Carton Box Change for Various Sensors and Controls

SC2209

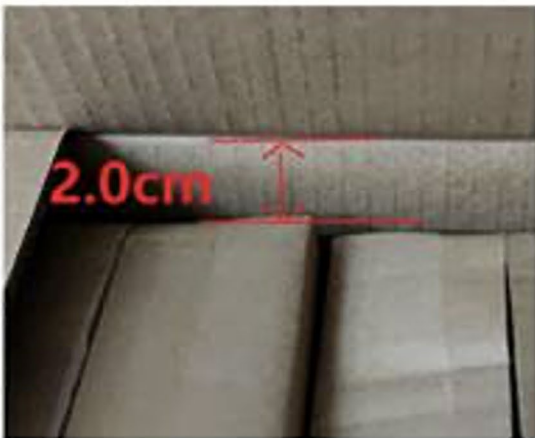
Riverside, California – June 22, 2022 – In the spirit of continuous improvement, effective immediately, Bourns will change the design of the carton box used for various [Sensors and Controls](#). As depicted below, this change will reduce the gap between the inner boxes and carton, thereby decreasing the available space for the boxes to shake in the carton during transportation.

Old Carton Box

Carton size: 55 x 29 x 23 cm

Gap of height between inner box and carton: 2 cm

Gap of length between inner box and carton: 1 cm

New Carton Box

Carton size: 54 x 29 x 21.5 cm

Gap of height between inner box and carton: 0.5 cm

Gap of length between inner box and carton: None
